Docket Number:	13-AFC-01
Project Title:	Alamitos Energy Center
TN #:	201620-46
Document Title:	AEC AFC Appendix 5.1F Dispersion Modeling Protocols
Description:	Previously TN# 201493-19
Filer:	Tiffani Winter
Organization:	CH2M Hill
Submitter Role:	Applicant Consultant
Submission Date:	2/3/2014 12:47:11 PM
Docketed Date:	2/3/2014

Appendix 5.1F
Dispersion Modeling Protocol

Alamitos Energy Center - Response to USFS FLM Comments on the AQRV Protocol

This technical memorandum summarizes the USFS comments on the AQRV modeling protocol and each comment is followed by a detailed response. Supporting documentation for the responses is attached to this memorandum.

Figure 2-1. 36km (D01), 12km (D02) and 4km (D03) MM5 Domain.

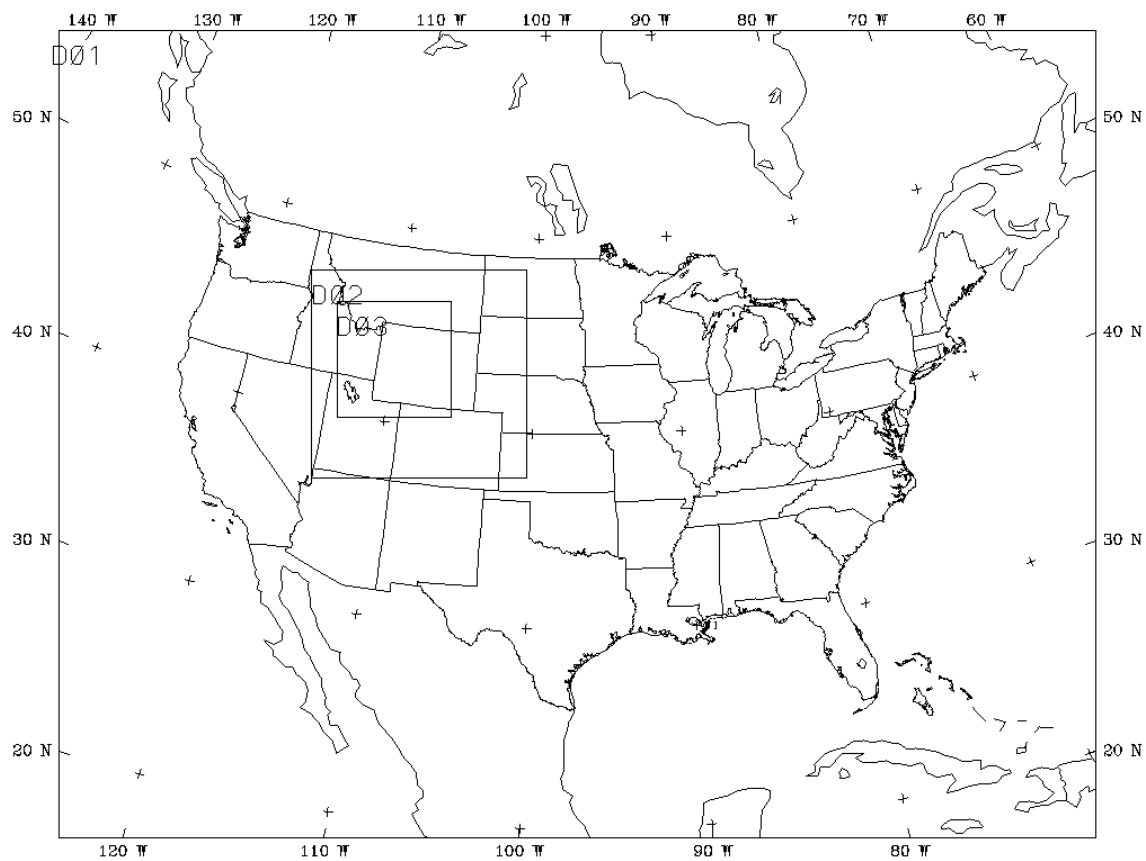
Comment 1: [Please provide] MM5 data documentation [including]: source of data, horizontal/vertical resolution, physics options, and performance evaluation.

Response: As described in the AQRV modeling protocol, MM5 data for years 2006, 2007, and 2008 are proposed for this analysis. The MM5 data is of 36-kilometer (km) horizontal resolution and developed by Alpine Geophysics, LLC.

For the 12-km and 36-km domains, the statistical values were compared with similar model performance evaluation statistics from MM5 simulations performed in previous studies upon the same or very similar grid domains. Based on this comparison, the current simulation has performance characteristics that are similar to prior studies. Of the simulations examined, no one simulation exhibits consistently superior performance. Therefore, the current MM5 simulation is performing at par with other simulations that are currently being used for air quality planning so the overall performance of the model is judged to be adequate (Alpine Geophysics, LLC, 2008. *Evaluation of 36/12/4 km MM5 for Calendar Year 2006 over the Continental and Western United States with Emphasis in Southwestern Wyoming*. December).
